## **Consolidated information on initial & additional postponements and responses to technical clarifications: Natref**

### **A. Responses to technical clarification questions**

Figure 1: proposed compliance monitoring point for 1 April 2015 – 1 April 2018

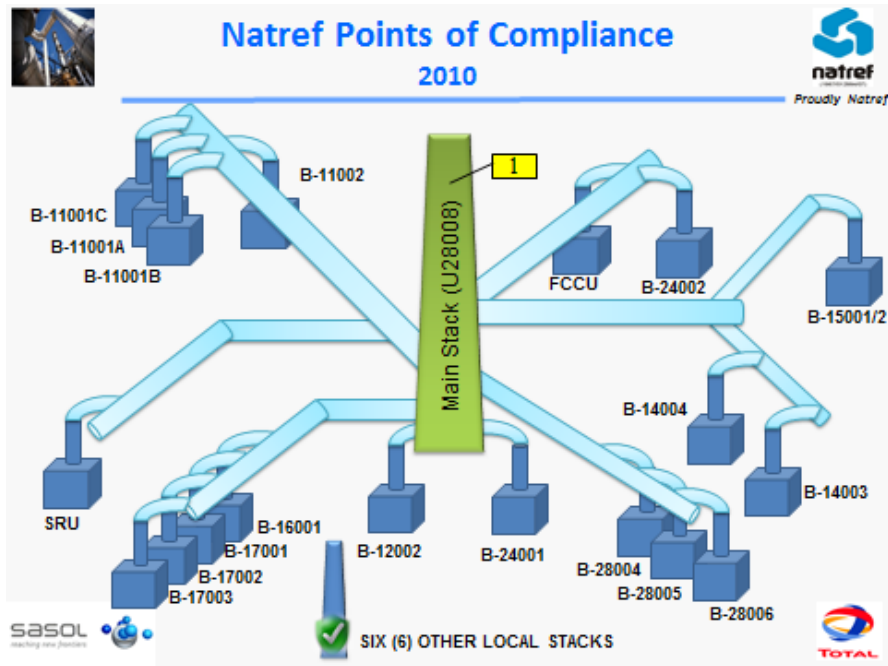
#### **1. Why has Natref proposed a certain set of limits to apply from 1 April 2015 to 1 April 2018 and a different set to apply from 1 April 2018 to 1 April 2020?**

Natref's current point of compliance as defined in its licence is the main stack (for all emission sources tied into this stack), as well as six separate "local" stacks (Figure 1). It is currently only possible to sample at the main stack and at each of the 6 local stacks. The 'point of compliance' definition included in Part 2 of the 2013 Minimum Emissions Standards (MES) requires Natref to install 11 additional sample points at various ducts tied into the main stack (Figure 2). Natref has requested postponement until 1 April 2018 to install these sampling points. Since measurements are not presently available at these 11 new points, emissions of the points into the main stack have been estimated via theoretical calculations. These calculations will be verified by measurements once sample points are installed.

Hence, the alternative emission limits requested between April 2015 and April 2018 will be emission limits applicable to the main stack (i.e. point 1 in Figure 1), which are in line with Natref's currently applicable license conditions, and converted to align with the prescribed MES conditions of 10% O<sub>2</sub> reference and on a dry basis, expressed in concentrations. The limits requested for this category are reproduced in Table 1 below, as extracted from Table 4 of the final motivation report for initial postponements, page 21. Six existing local stacks (each one being a point of compliance as defined in the 2013 MES) are already measured in accordance with requirements and are fully compliant with the 2020 new plant standards.

For the period 1 April 2015 to 1 April 2018 Natref therefore requests that the main stack (as the point source) is regarded as the point of compliance for all those listed activities whose emissions exit via the main stack, where a single emission limit would be specified and can be measured to verify compliance thereto.
